TECHNICAL BULLETIN INDEX
Sorted by Bulletin Number
04/03/86

BULLETIN NO: II:1

PRODUCT: 26-4001/2 Model II

SUBASSEMBLY: AXX-0505 FDC Board Early Design (All Revisions)
AX-9033 FDC Board Late Design (All Revisions)

Figure 1

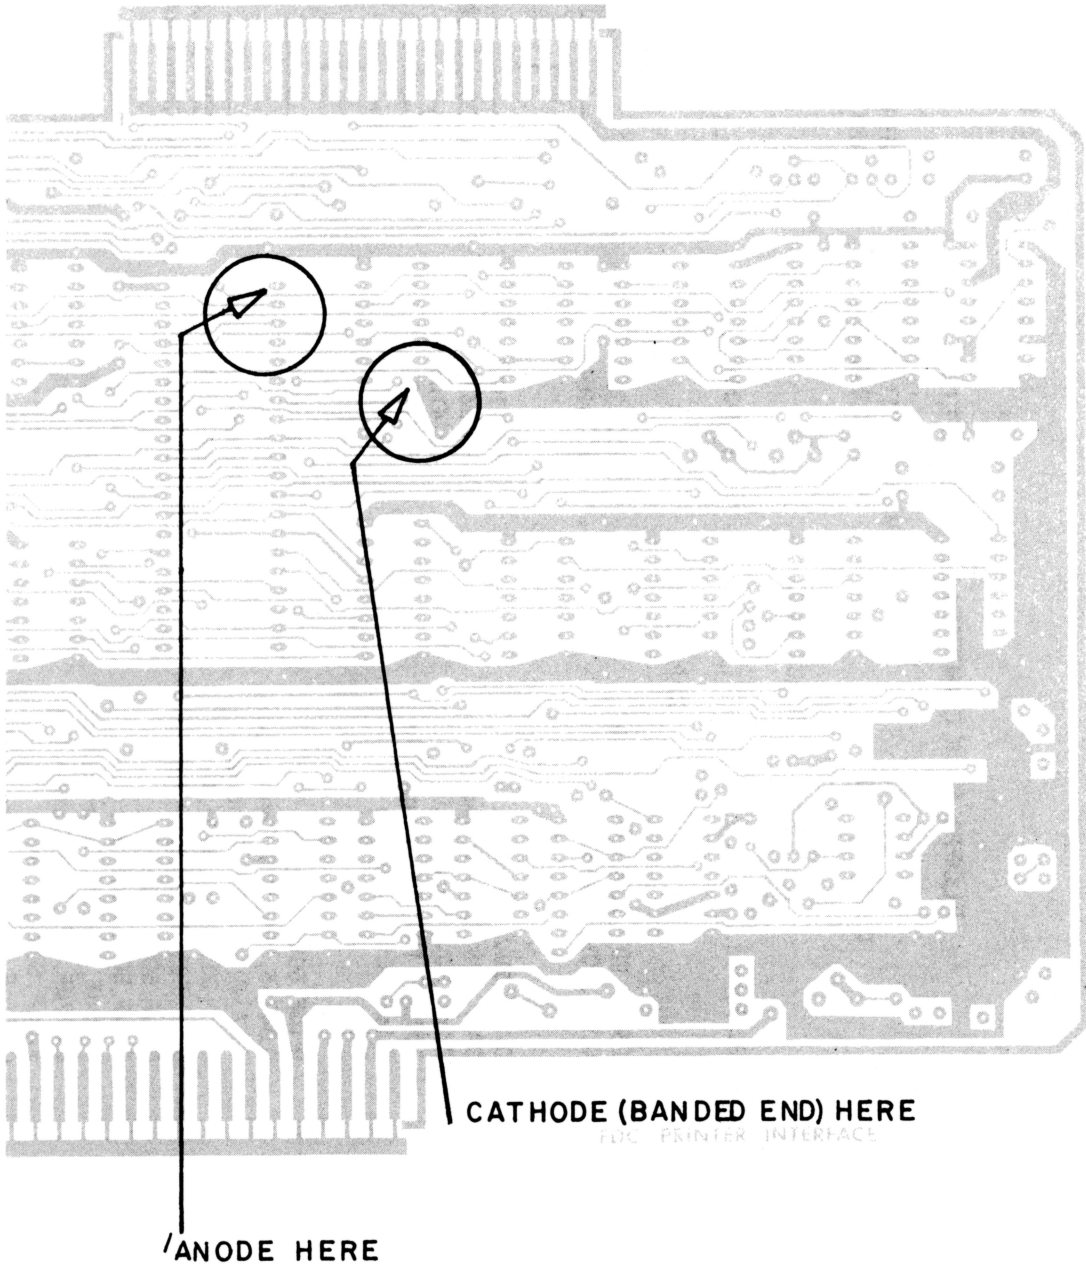
PURPOSE: To correct thermal failure of FDC IC (U6) causing Read/Write errors, and other intermittent disk I/O failures.

DISCUSSION: Early FDC chips developed thermal failures causing disk I/O failures and Read/Write errors. To correct this problem a 2.7V Zener diode **MUST** be installed from U6 Pin 1 to U5 Pin 7. On new and factory repaired assemblies this change will already have been installed.

PROCEDURE: Check to see if this modification has been done, if not, install diode as per Figure 1. Be sure to use sleeving for insulation of leads to prevent shorts. This diode can be ordered from National Parts using part number ADX-1382 and catalog number 26-4001.

Figure 1

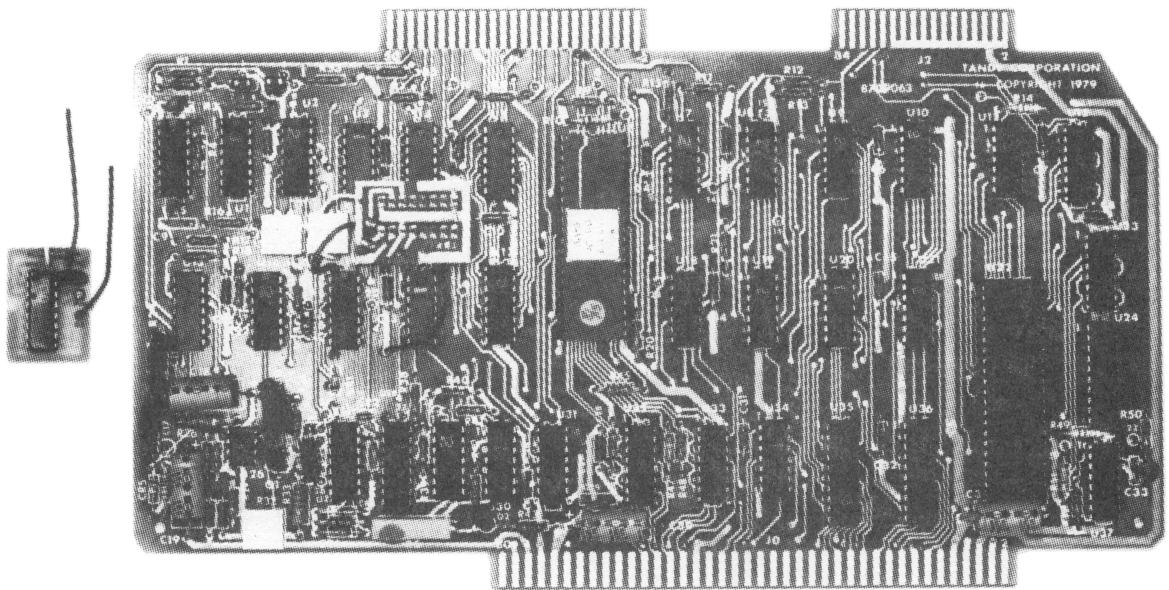
DISCUSSION: Early Design Rev A and B FDC boards require a modification to stretch the write pulse for proper operation with CDC LSI Logic Boards. This is accomplished by adding a satellite board (AXX-0506) to the existing circuitry. Rev C FDC boards have this modification incorporated on them so the modification is not required. To double check the Rev level of the board locate R49. On Rev B boards R49 is located next to the PIO chip (U22) and on Rev C boards R49 is located between U34 and U35.

Figure 1 is a Rev B FDC Board with the satellite board modification.

1. Cut trace on foil side of the board running from U3 Pin 1 to U16 Pin 3.
2. Dress red, black, and white wires coming from the satellite board to follow the routing shown in Figure 1.
3. Remove solder from the PCB pad that is to receive the stake pin. This is the pad connected to U16 pin 3.
4. Invert satellite module, insert stake pin, and solder the stake pin into place.
5. Reflow solder in unused PCB pads while inserting tinned satellite module leads as shown in Figure 1.
6. Align the FDC board as outlined in the FDCALG diagnostic alignment procedures. Alignment is **MANDATORY** after performing this modification.

Figure 1

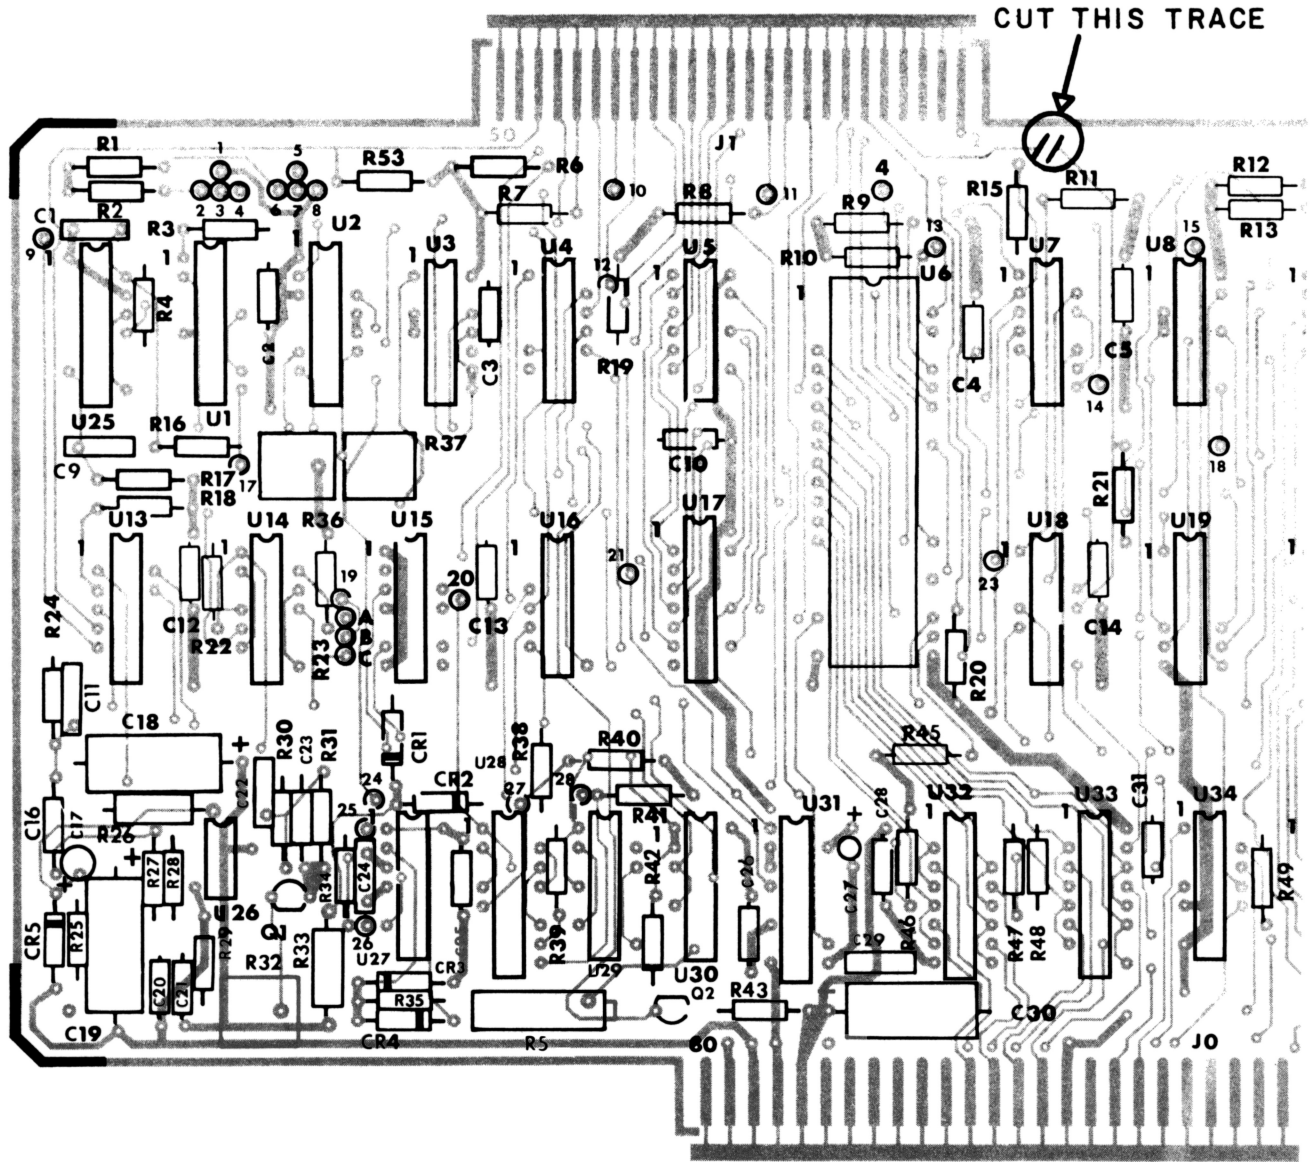
PURPOSE: To prevent Xenix from thinking there is a double sided disk in drive 0 when a terminator is used.

DISCUSSION: The terminator that is used with the Model II ties pin 10 of the disk drive card edge to pin 34. This takes the direction line (pin 34) and connects it to a previously unused line (pin 10) which has a pullup resistor R21 installed on it. Xenix looks at pin 10 to determine if the diskette in the current drive is single or double sided. With the terminator installed this signal will change depending on the direction the drive was last stepped. To correct this problem the trace connected to pin 10 of the FDC board should be cut. This will prevent the customer from being able to use double sided drives, which Radio Shack does not support in the Model II. This modification should only be done to Model IIs that have the 26-6010 enhancement kit installed and an old style FDC board.

PROCEDURE: Locate and cut the trace connected to pin 10 of the disk drive connector on the FDC board (Refer to Figure 1).

Figure 1

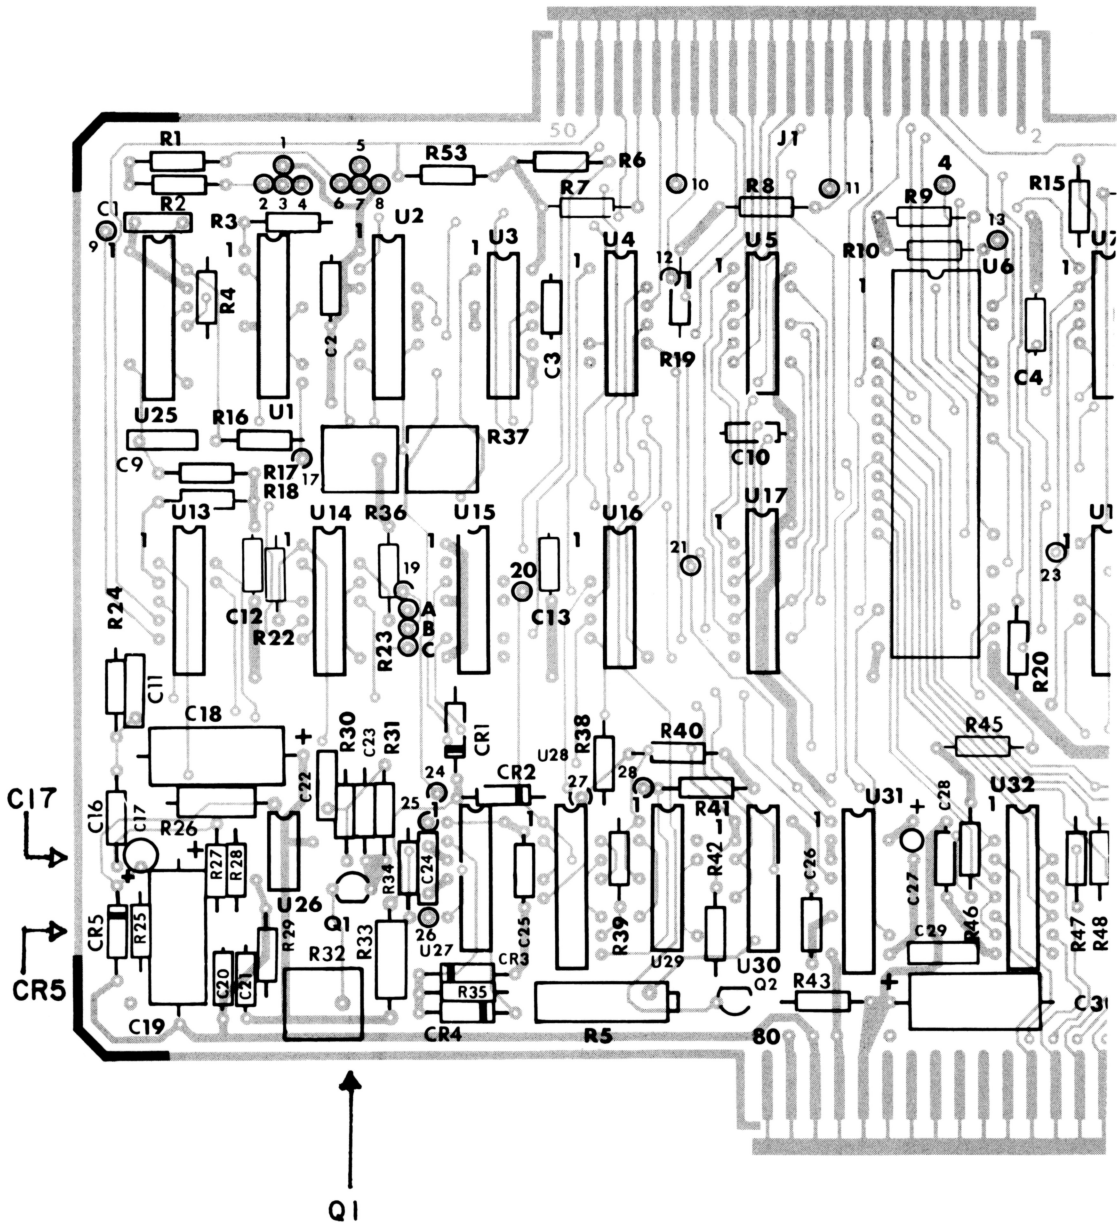
PURPOSE: To correct FDC Boards which have C17 installed backwards.

PROCEDURE: Check C17 on all units in for service to insure the positive(+) lead is going to ground. The most accurate method of checking this is by actually checking with an ohm meter continuity between the positive lead of C17 to ground. If capacitor is installed backwards replace with a new .47ufd tantalum capacitor(ACC-474MGTP). Do not just turn the old capacitor around as it has started degrading and life expectancy shortened.

FIG. 1

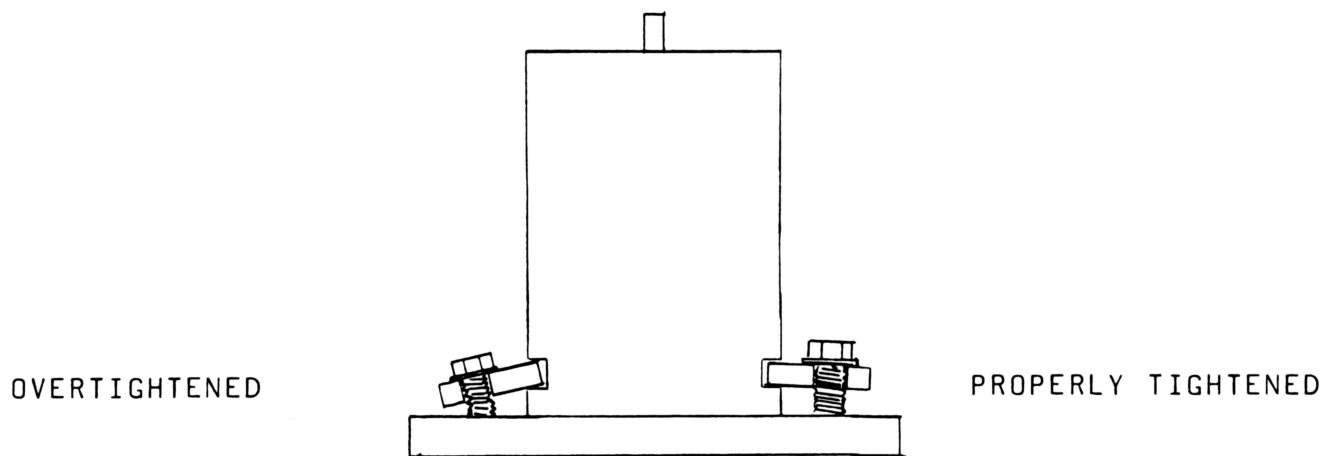
DISCUSSION: After aligning Head Radial DO NOT OVERTIGHTEN bracket screws when securing the stepper motor. Excessive tightening will cause bracket and screws to bend and eventually damage the screw holes in the stepper motor plate, making proper alignment almost impossible.

PROCEDURE: After Head Radial Alignment tighten bracket screws only enough to secure stepper motor. If the stepper motor cannot be secured without excessively bending the bracket (Refer to Figure 1), or if the screw holes in the plate are damaged, replace the drive chassis.

FIG 1

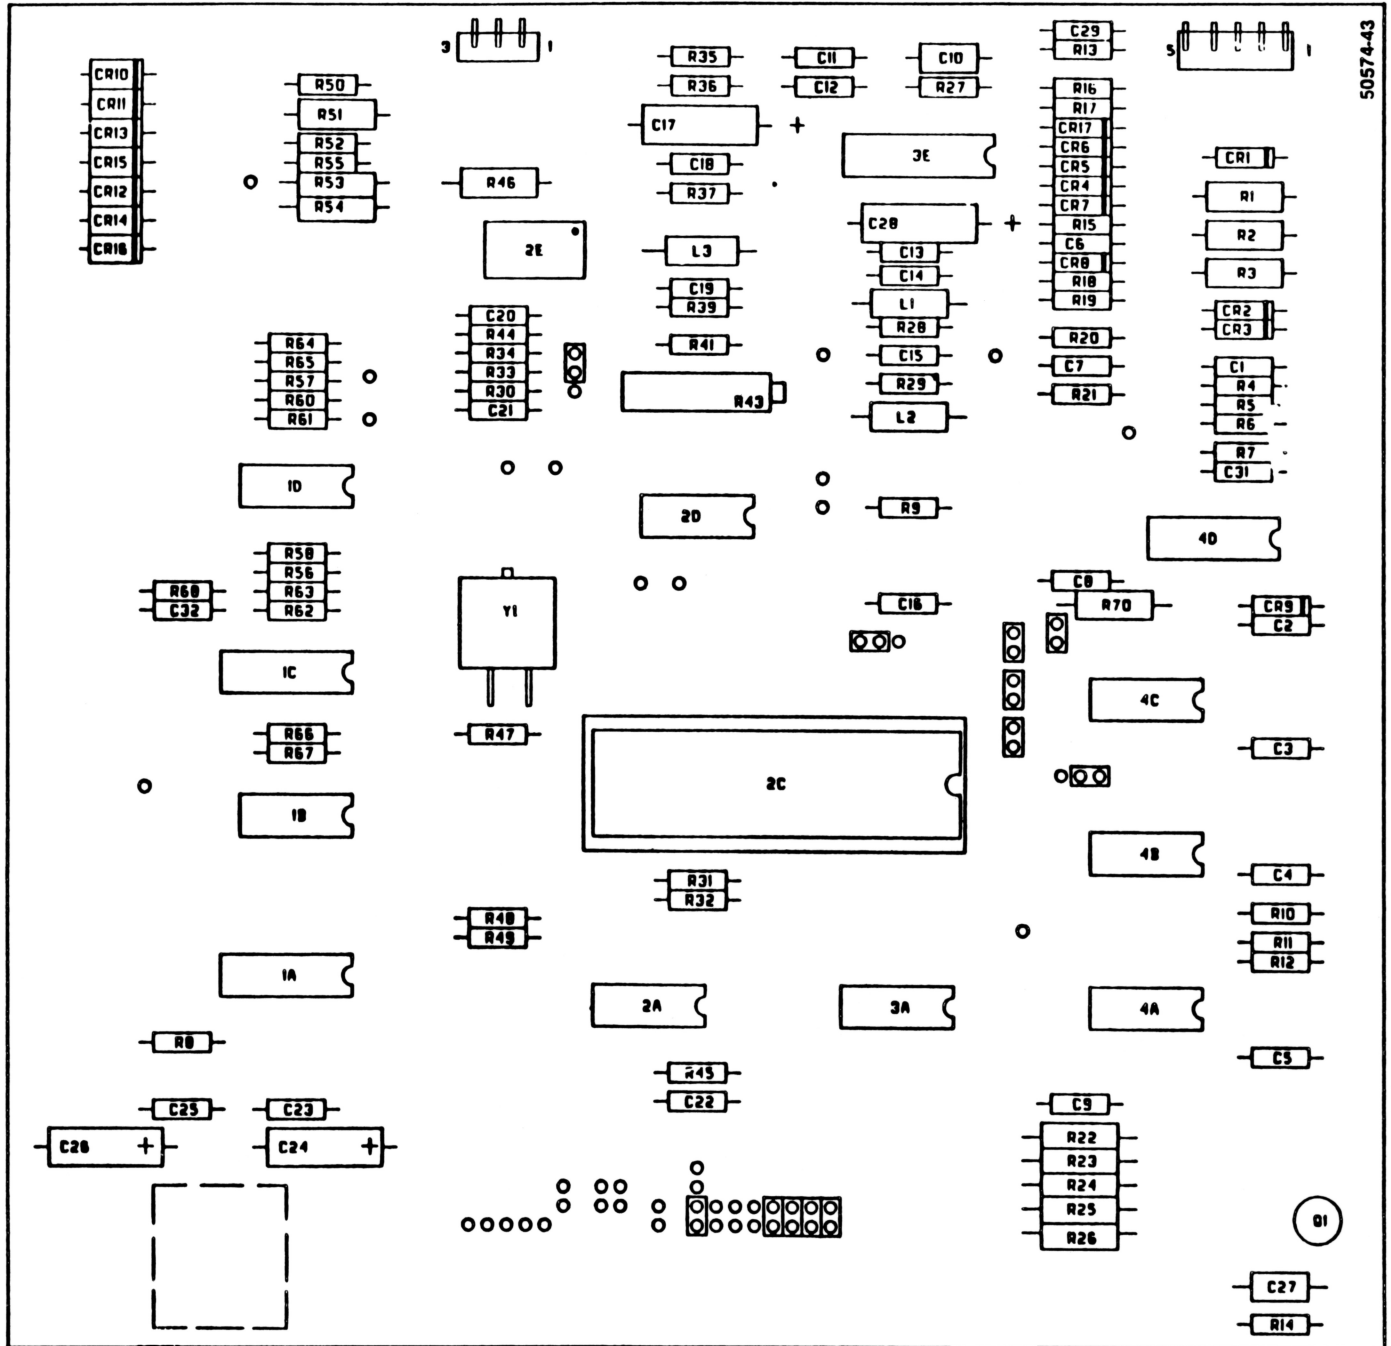
PURPOSE: To correct problem of getting Boot Error DC usually after running Scripsit.

PROCEDURE: SOLUTION 1: Check board to insure .47 ufd capacitor is installed across C21 (Refer to Figure 1). This capacitor should be on all LSI boards, if not present, install capacitor with negative lead going to ground. Any value from .47ufd to .68ufd is acceptable. ACC-474MGTP is the National Parts Number for a .47ufd 35V capacitor. Later boards had the capacitor value at C21 changed.

Figure 1

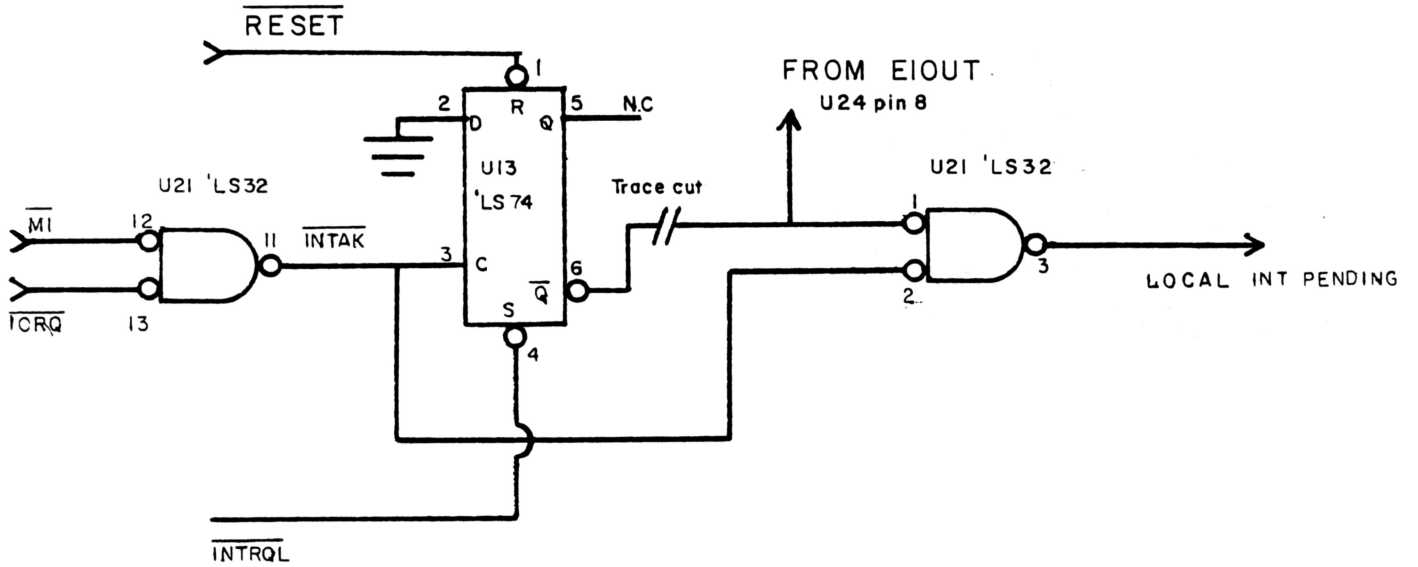
Refer to Figure 1 for schematic changes affected by this modification. The signal Local Interrupt Pending is now ANDed with EIOUT, and not with INTRQL. Previously, if the SIO programming was changed with interrupts disabled, a local interrupt could set flip-flop U13 without being serviced. Later, when an off board interrupt occurred, the bus steering logic would mistakenly interpret this as an on-board interrupt and would not turn the external data receive buffers. By ANDing the EIOUT signal with INTAK signal this problem is eliminated.

If the CPU board is a Rev A/B/C or no Rev letter, cut the trace on the back of the board between U13 pin 6 and U21 pin 1 and add a jumper wire between U21 pin 1 and U24 pin 8. Rev D, later Rev boards, and boards that have been modified for hard disk require NO cuts or jumper wires. However, the push on jumpers must be changed on all boards.

Figure 1

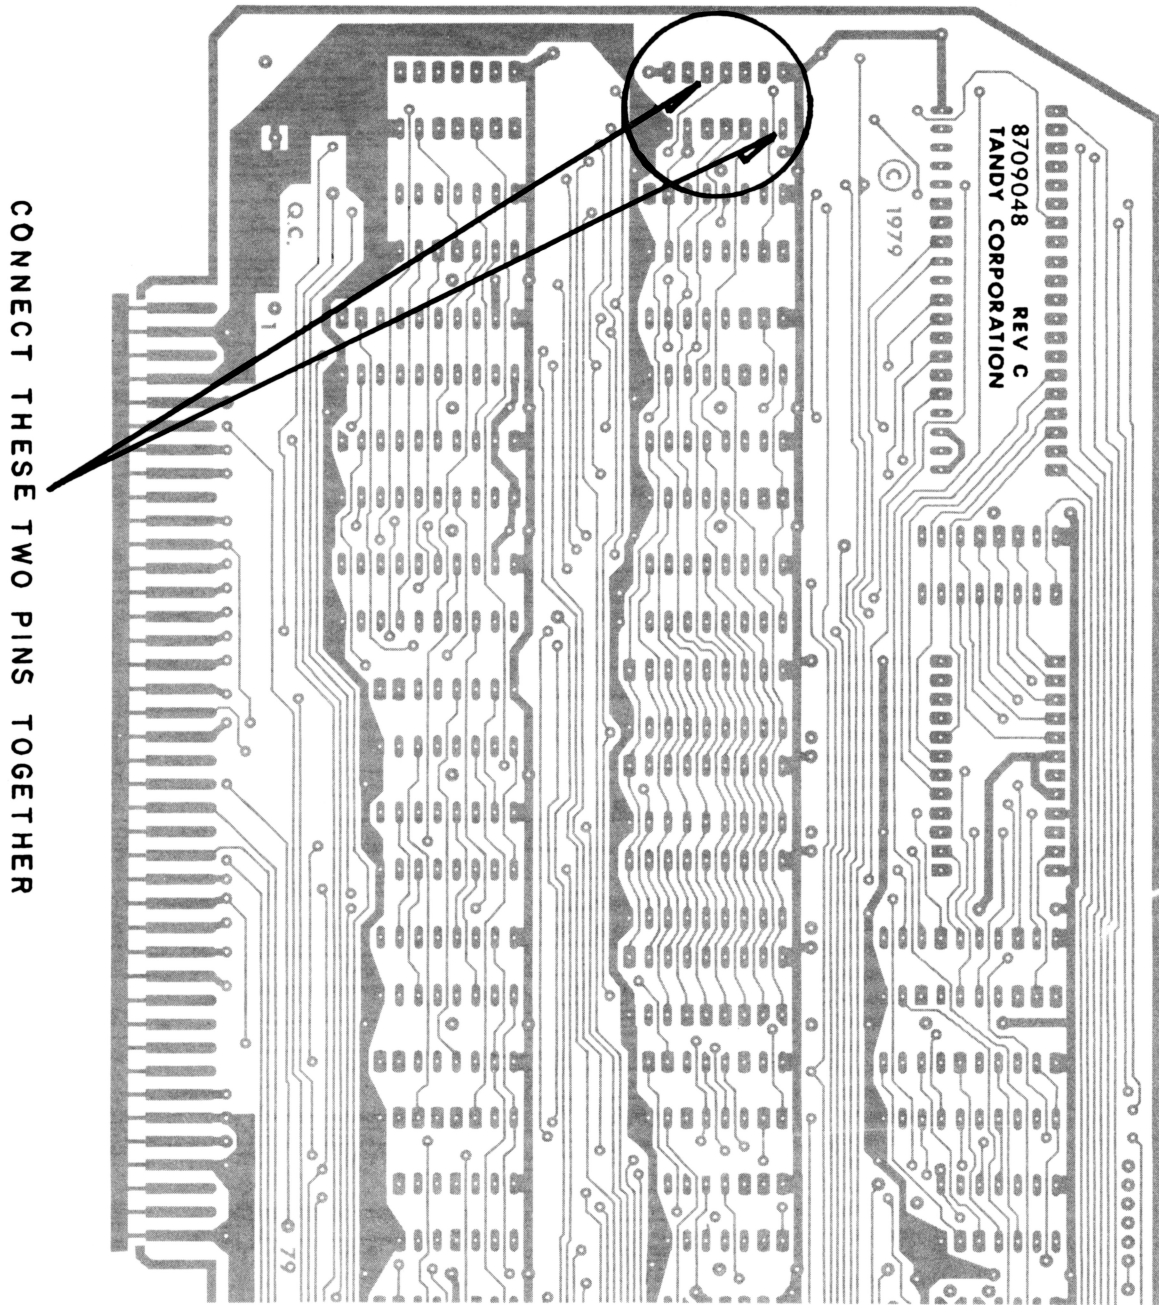
PURPOSE: To correct dual addressing on Video/Keyboard Interface boards (Rev A/B).

DISCUSSION: Rev A and B VDG boards have a problem with dual addressing. Addresses FC through FF are decoded on the VDG board for use by the Model II. There is an image of these addresses from 7C through 7F. Most systems will not have hardware port mapped at these addresses so no problem will appear. The only time a problem may arise is if a system has hardware installed that is port mapped in the range of 7C through 7F. This problem was corrected on Rev C VDG boards.

PROCEDURE: Whenever a Rev C VDG board is replaced with a Rev A or B VDG board jumper pin 1 to pin 10 of U27 on the Rev A or B board to insure no addressing conflict of the VDG board (Refer to Figure 1).
